**LOUISIANA**  
POWER & LIGHT

SUBJECT: Waterford SES Unit No. 3  
Docket No. 50-382  
Safety Parameter Display System

JUSTIFICATION FOR THE PARAMETERS SELECTED  
IN THE FEBRUARY 14, 1986 PROPOSAL

TENTATIVE SPDS DISPLAY

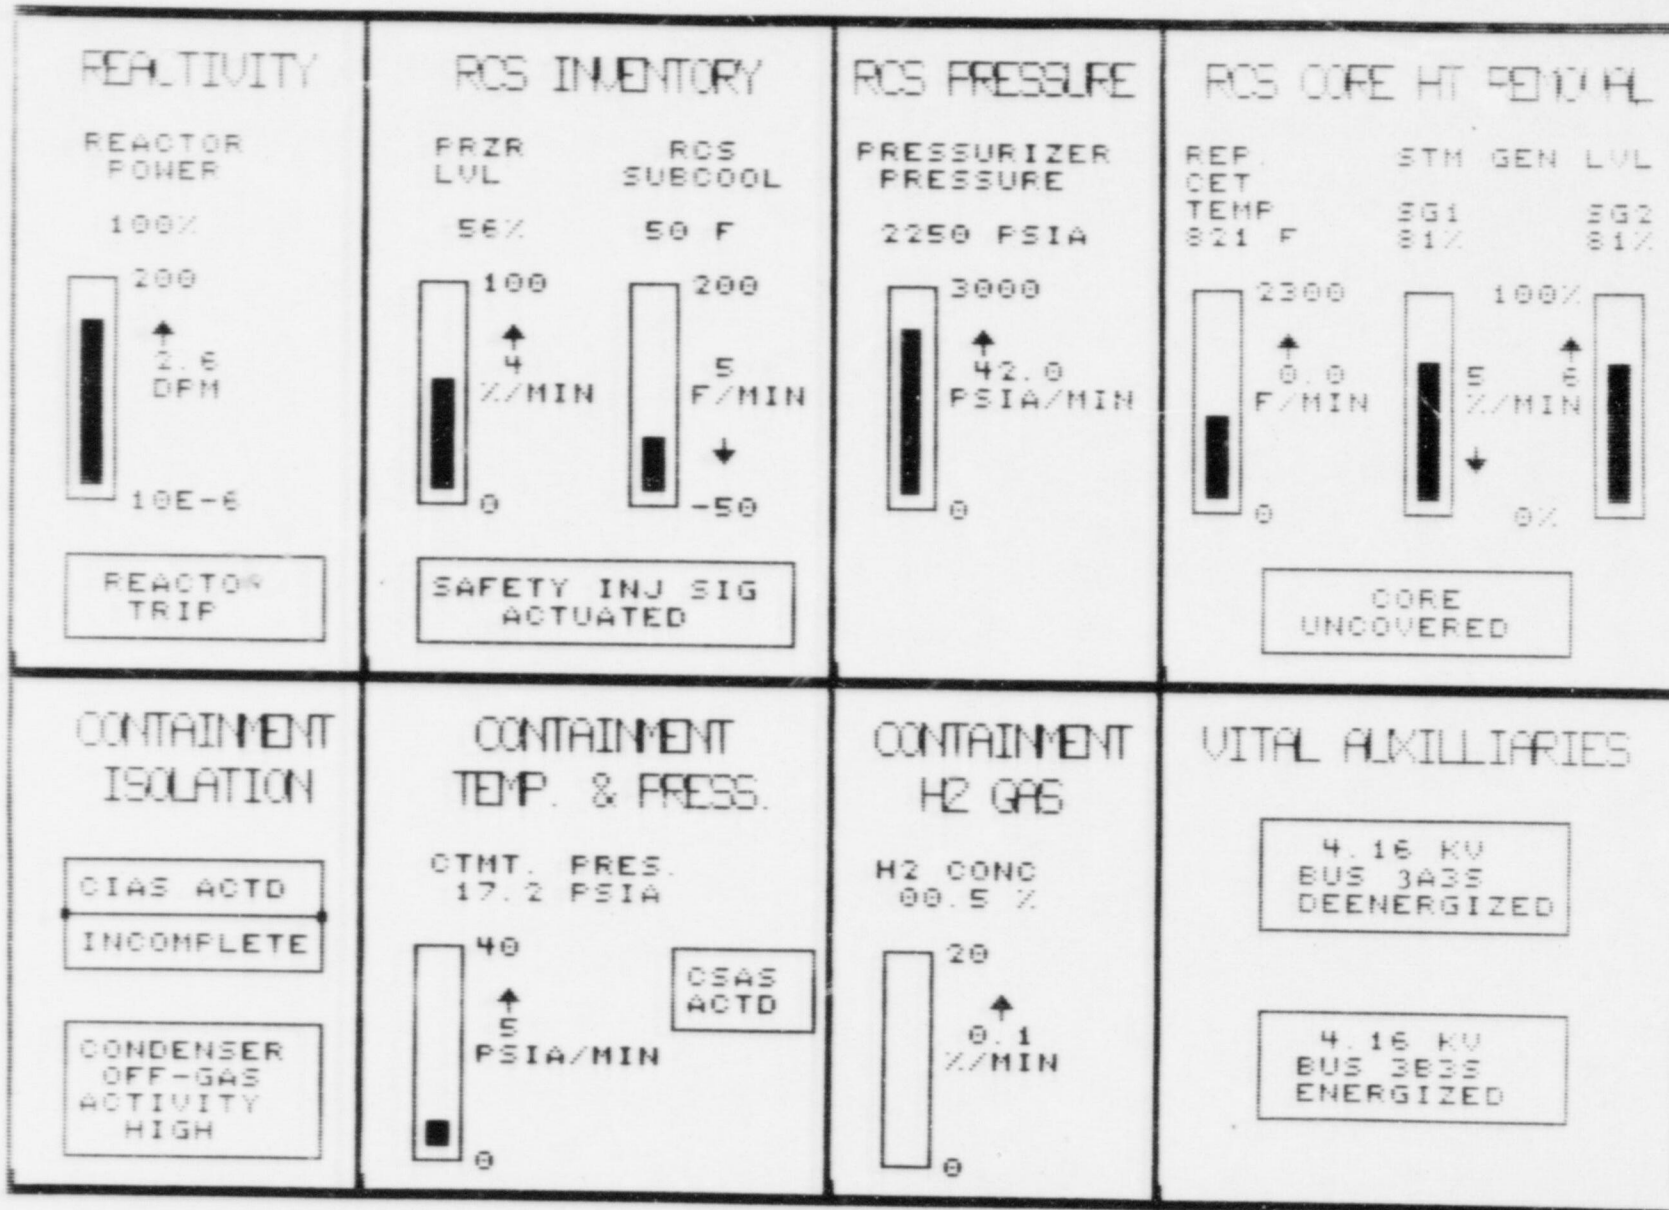
As a result of the May, 1986 meeting, LP&L has re-evaluated the SPDS design submitted in Reference 2. Based on operations considerations (including the justification provided in Attachment 1), we have determined that the parameters selected are adequate to perform the functions of the SPDS. Additionally, a cost analysis was performed on the options available to enhance the present SPDS design. The options available are to implement the design proposal submitted in Reference 2, (Option 1), to restructure the present design to include the incorporation of a few alternatives that could remedy some of the concerns noted in Reference 3, (Option 2), or to purchase a vendor approved SPDS system, (Option 3). Due to the monumental impact that the implementation of Option 3 would have on plant operations (e.g., implementation would have to be done during a refueling outage, several cable penetrations would have to be removed and rerouted, and existing hardware and software would have to be replaced) as well as the extremely high cost associated with it, Option 3 was deleted from the analysis. The following represents a cost breakdown of Options 1 and 2:

To implement one SPDS display based on the proposal submitted in Reference 2 (See Attachment 2)

Based on the operations considerations and the cost analysis presented above, LP&L feels that the expenditure of an additional \$50,000 (Option 1) for the SPDS is justifiable and that the expenditure of an additional \$240,000 (Option 2) is cost prohibitive.
